Local Planning Panel

Address: 16-22 Cooper Street, Surry Hills

Application: D/2025/1198

Construction of an eight storey mixed-use development:

Cooper Street elevation of proposal

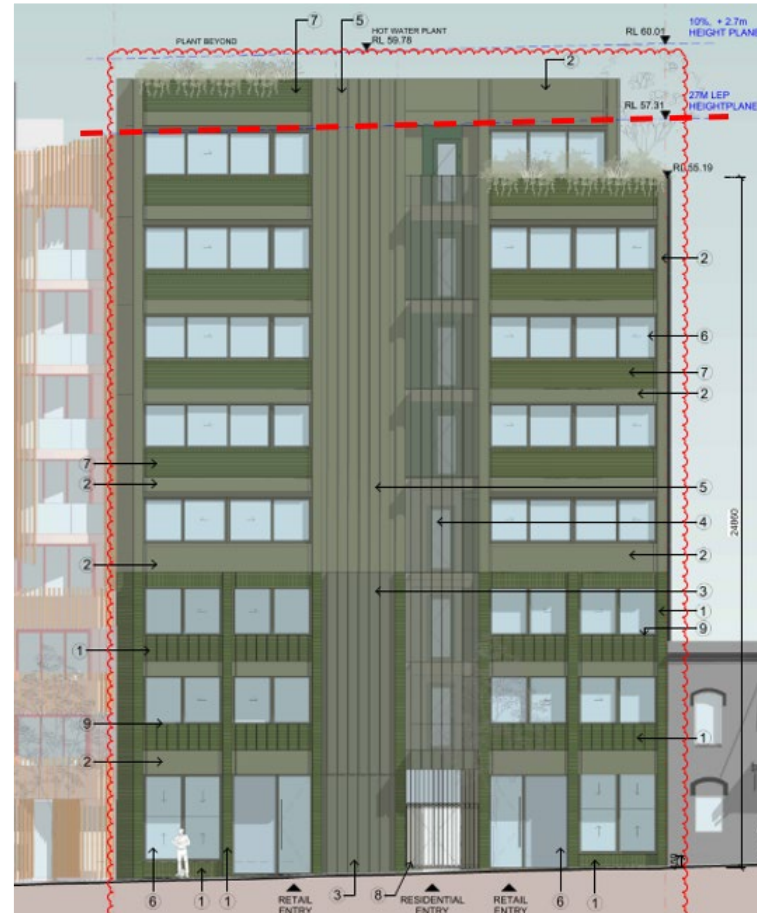
- non-compliance with 27m height control
- proposal is 29.7m
- complies with 8 storey DCP height control
- height is contextually appropriate
- height is generally consistent with the previously approved building envelope - D/2023/904 (29.67m)
- no unreasonable overshadowing or overlooking to neighbours
- CI 4.6 variation request is supported

Street frontage height

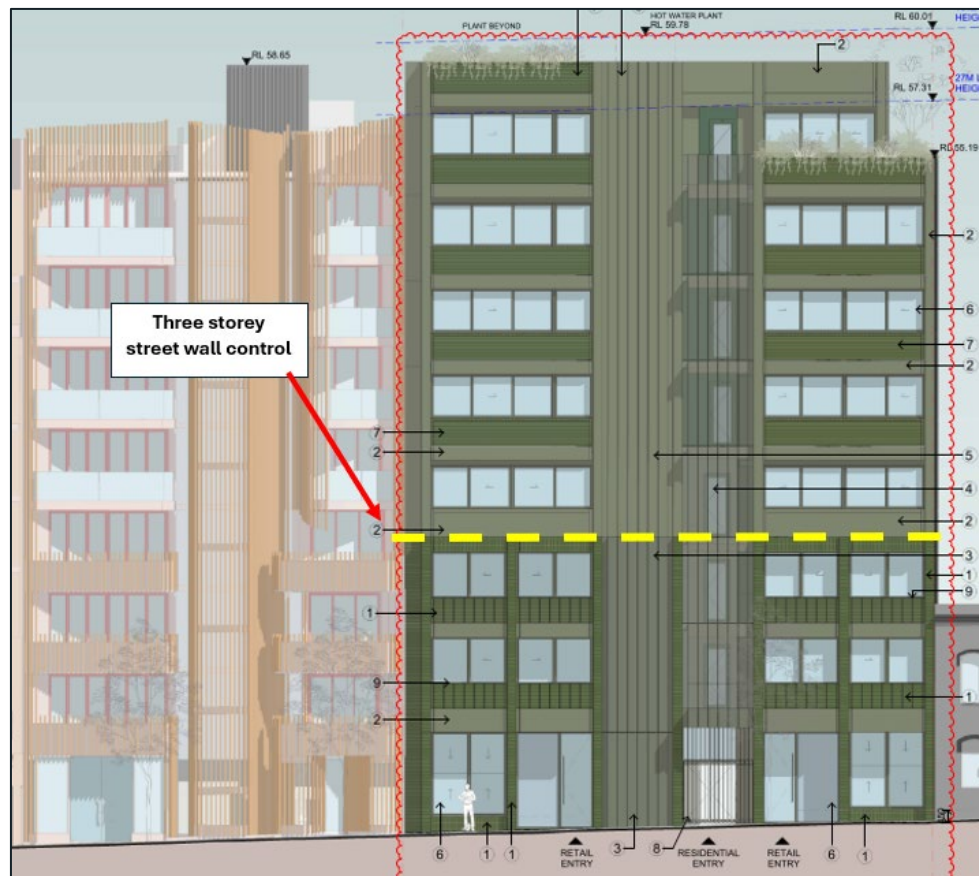
- three storey street wall height to Cooper St
- proposal incorporates a partial setback to upper levels
- splayed interface with neighbouring building at 10-14 Cooper St
- utilises materiality and architectural expression to acknowledge three storey street wall control

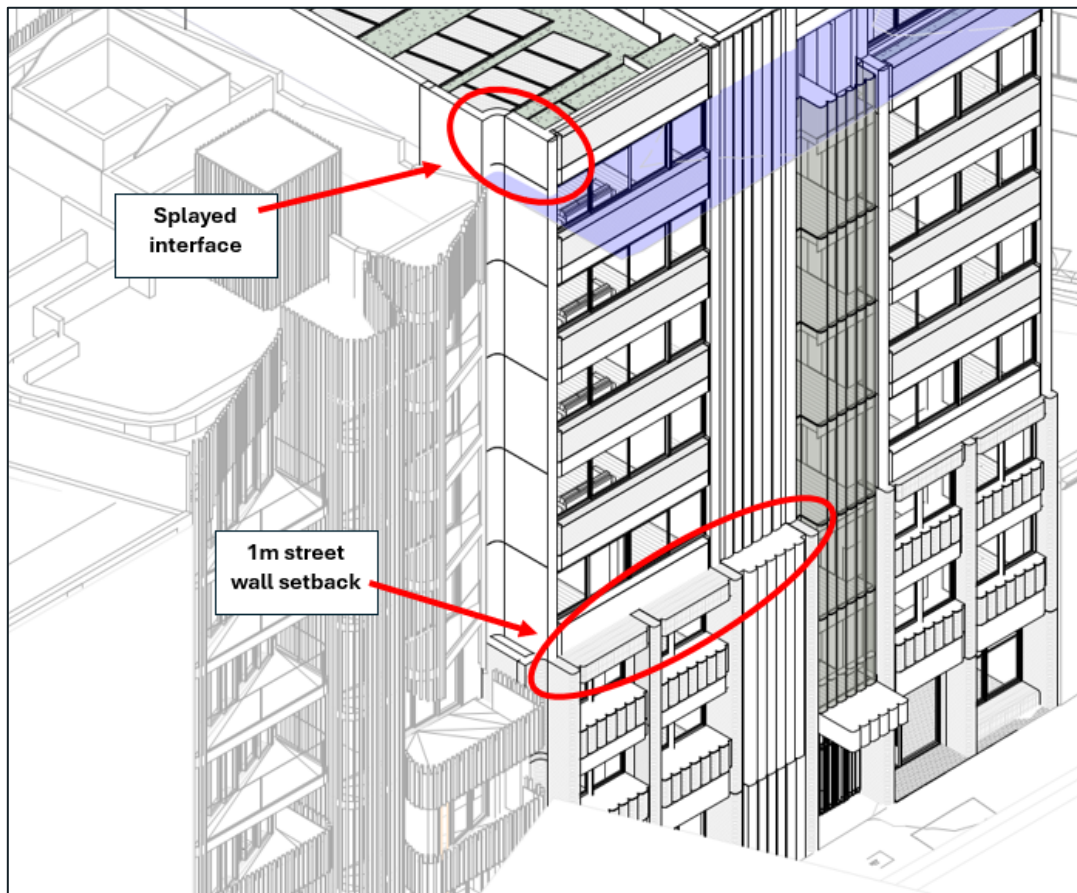
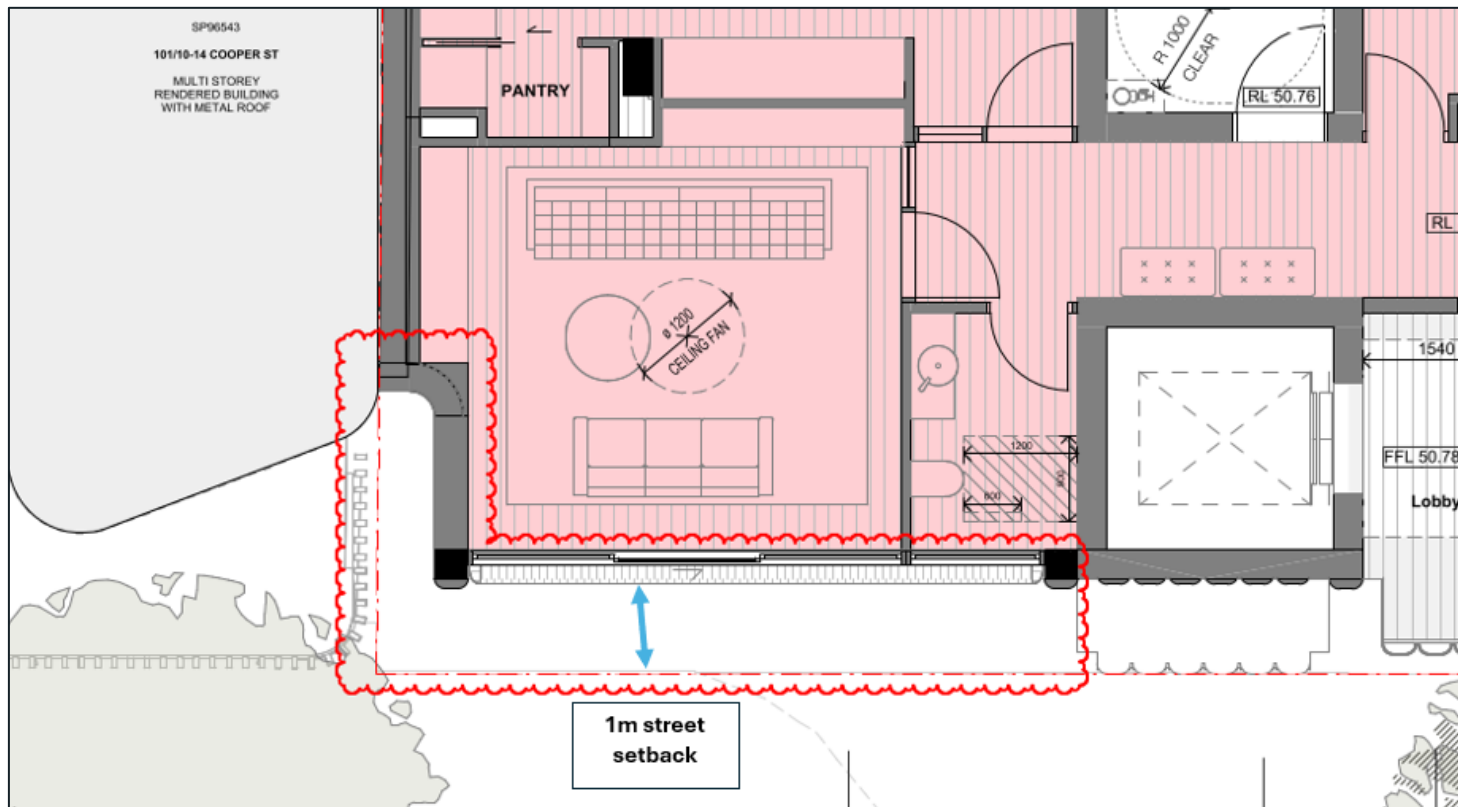
- PERFORATED METAL SCREEN TO LOBBY- 20% OPEN AREA (note 54% open area shown in image)
- PROFILED COLOURED CONCRETE TO EASTERN ELEVATION
- TERRAZZO CAPPING ADDED TO DEEP WINDOW SILLS
- GLAZED BRICK UPSTANDS REPLACE METALWORK ON SOUTH FACADE- DECORATIVE METALWORK REDUCED TO GATES ONLY

communal open space

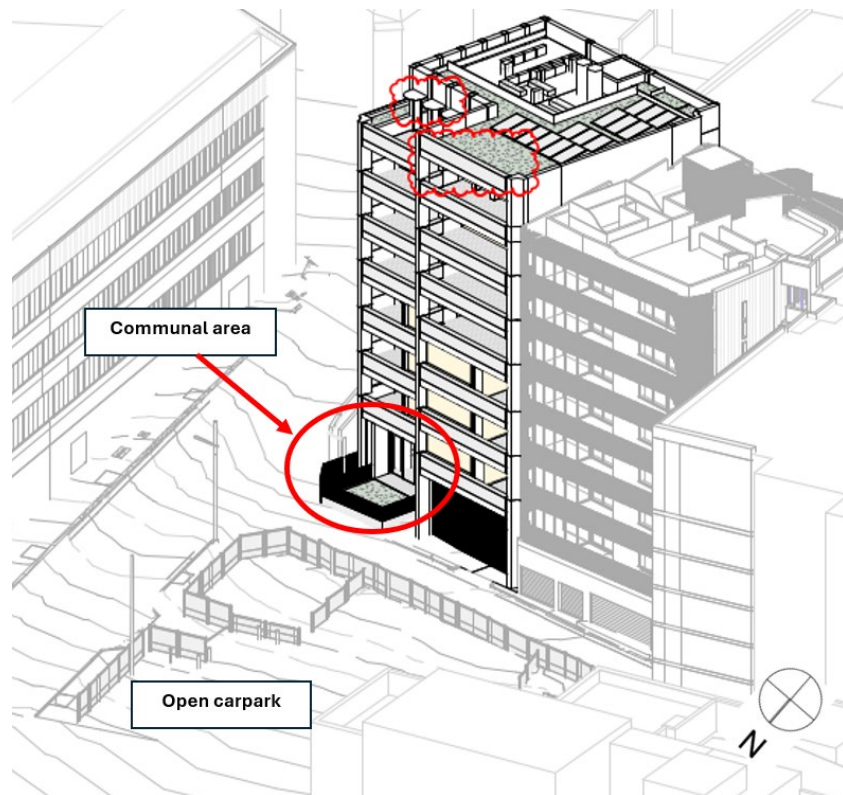
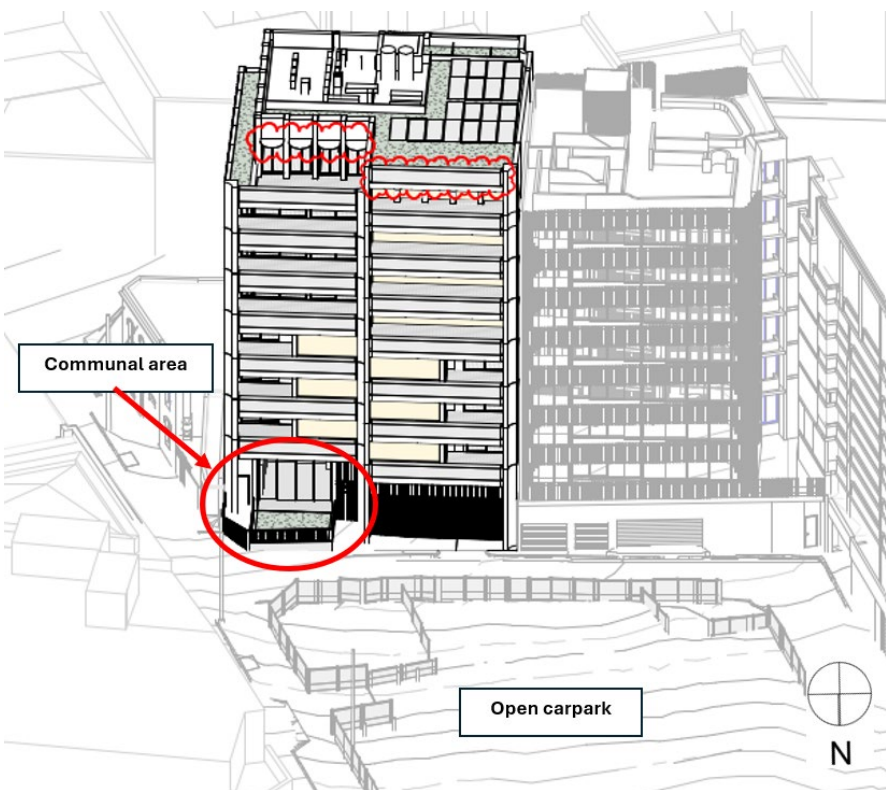
- non-compliance with 25% communal open space requirement of ADG
- proposal provides 14% (53 sqm) communal area at ground floor
- proposal meets ADG objectives and design criteria in that:
 - communal open space is co-located with deep soil area
 - provides kitchen facilities and enhances amenity
 - all apartments feature balconies which exceed ADG size requirements
- complies with DCP controls - incorporates soft landscaping, located with north aspect, passive surveillance to street, and provides for needs of residents

- ADG requires “direct sunlight to 50% the principal usable part of the communal open space for a minimum of 2 hours between 9am and 3pm mid-winter”
- communal open space receives direct sunlight to at least 50% of both the indoor and outdoor space from 11am to 2pm mid-winter
- any future development of the open car park will reduce direct sunlight

waste holding area

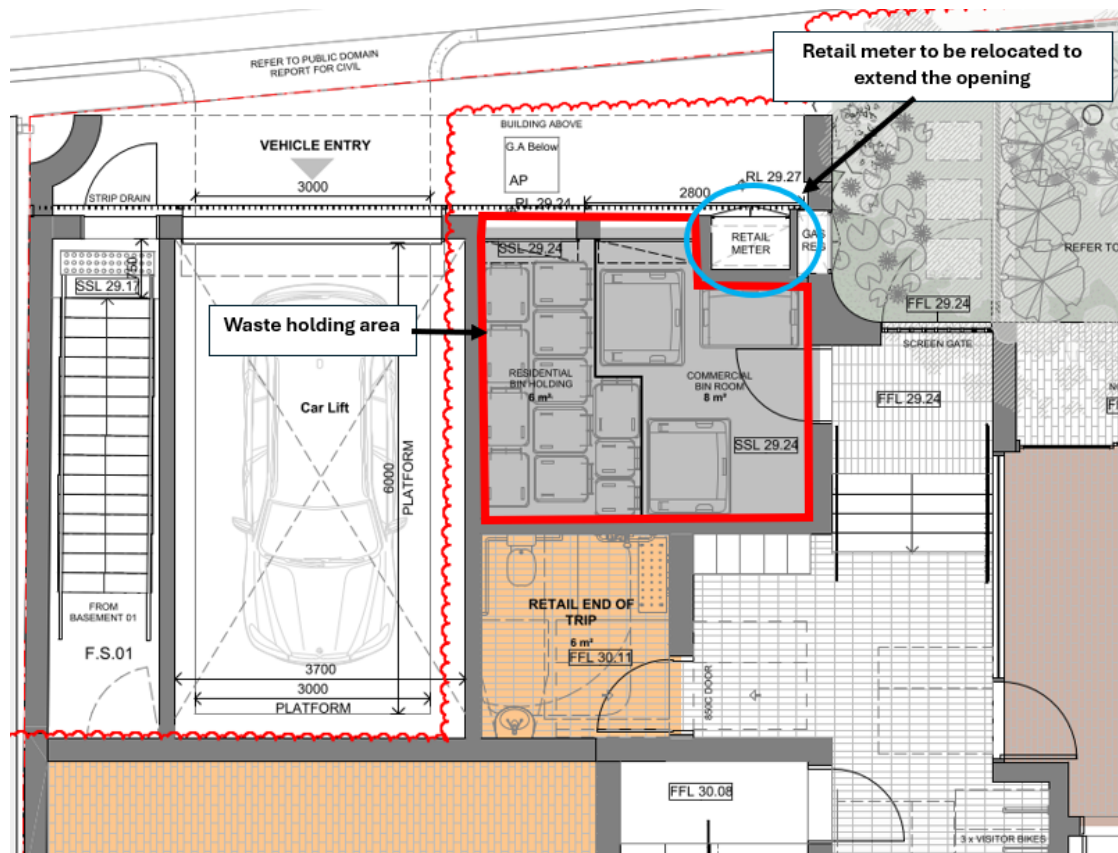
- waste holding area proposed at ground floor at rear of building
- space provided is insufficient to allow each waste stream to be wheeled out independently
- proposal meets ADG objectives and design criteria in that:
- condition recommended requiring waste holding area to be reconfigured to allow for improved access and sufficient circulation space

- reconfigure the ground floor waste area/bin room to improve access to bins and manoeuvrability
- provide physical materials and samples board
